Wisconsin Department of Transportation

Proposal #26: 1228-22-71, WISC 2021228
North-South Freeway
Capitol Drive to 2100' N of Hampton Ave.
IH-43
Milwaukee County

This is Addendum No.01, which provides for the following:

Addendum No. 01
ID 1228-22-71
Deleted Sheet 61
April 1, 2021

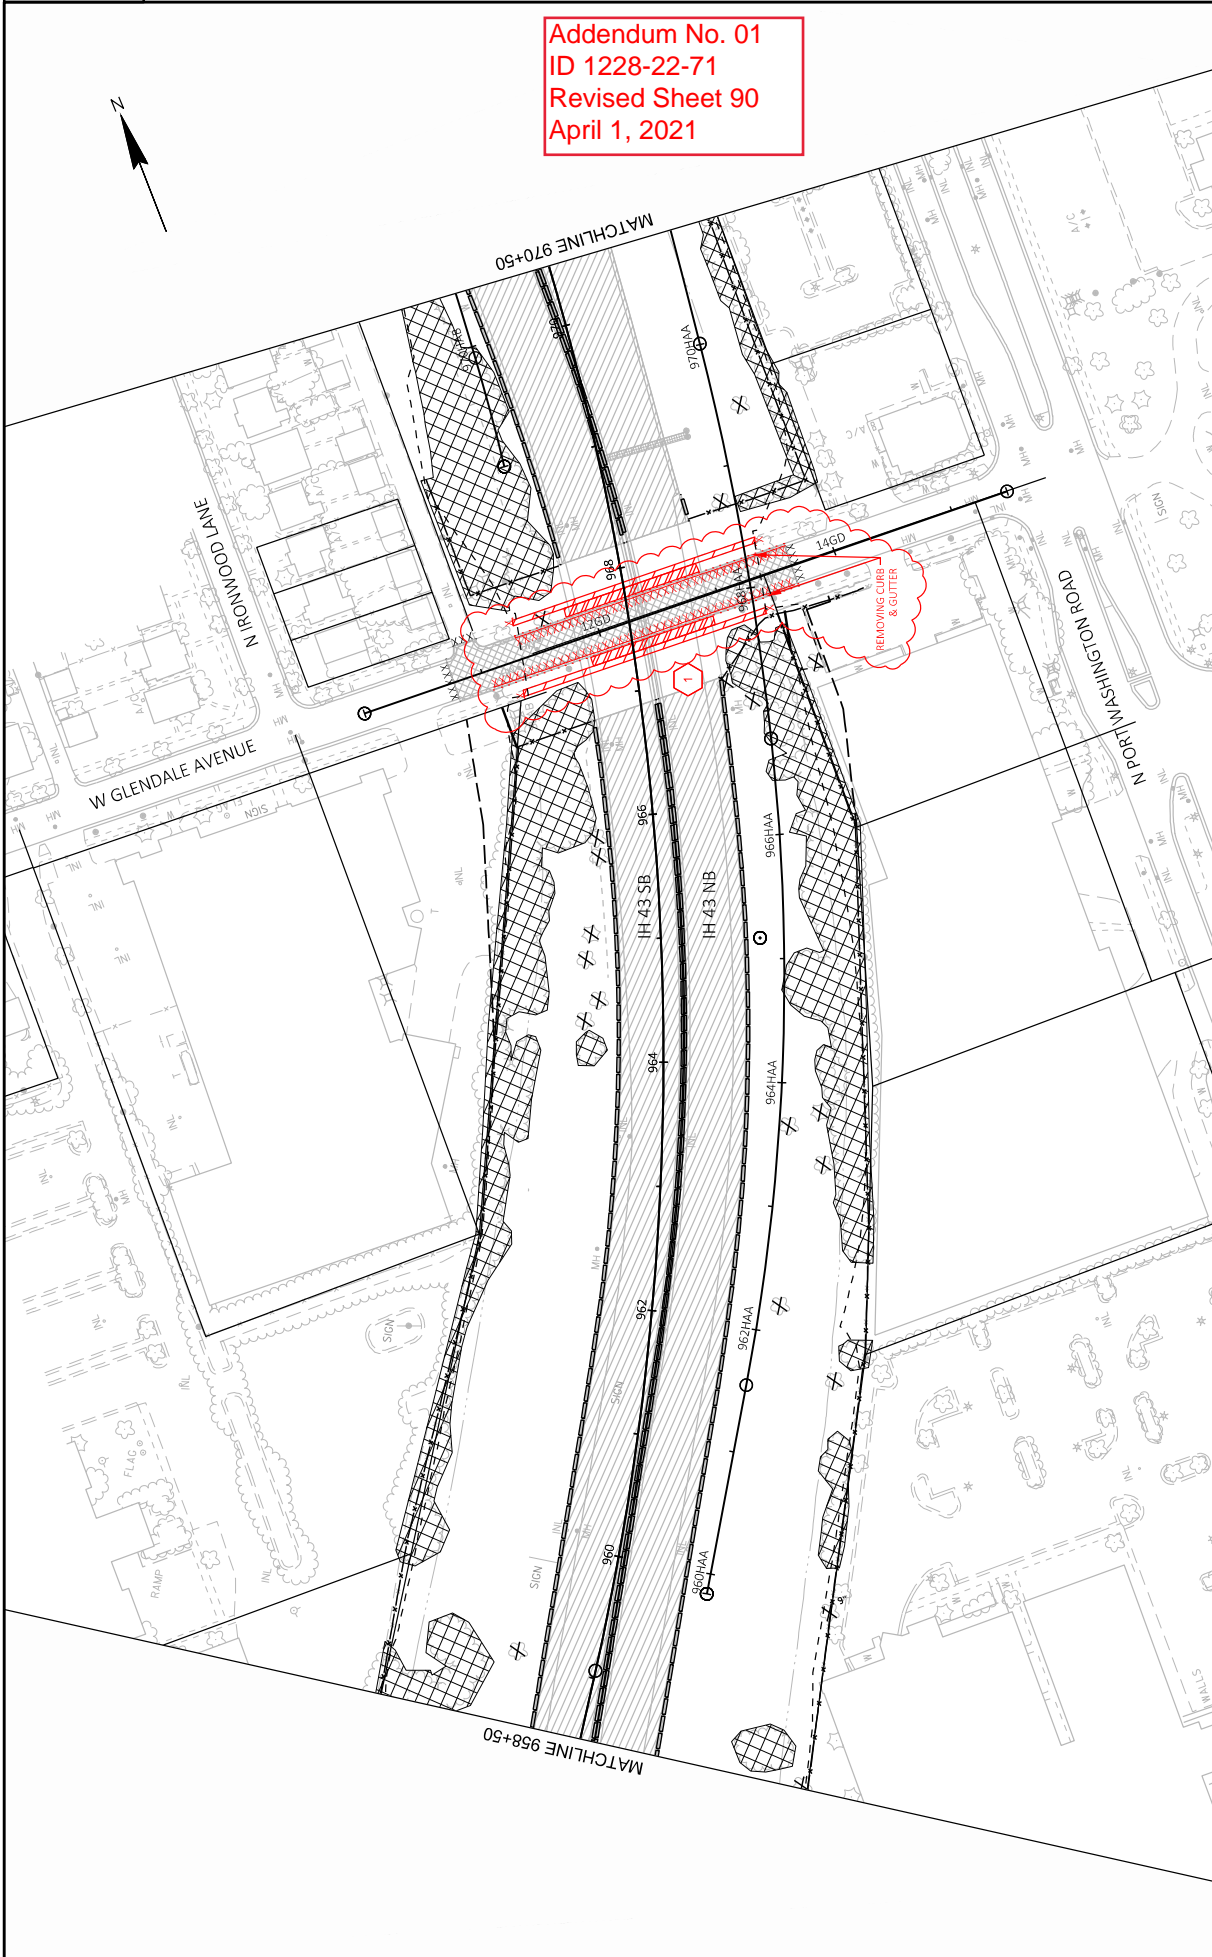
Deleted Plan Sheets	
Plan Sheet	Plan Sheet Title (brief description of why sheet was deleted)
61	Construction Detail, Removed HPC Detail
504	Ped Accommodations, Removed Ped accomodation sheet because a new traffic control plan was created for this area
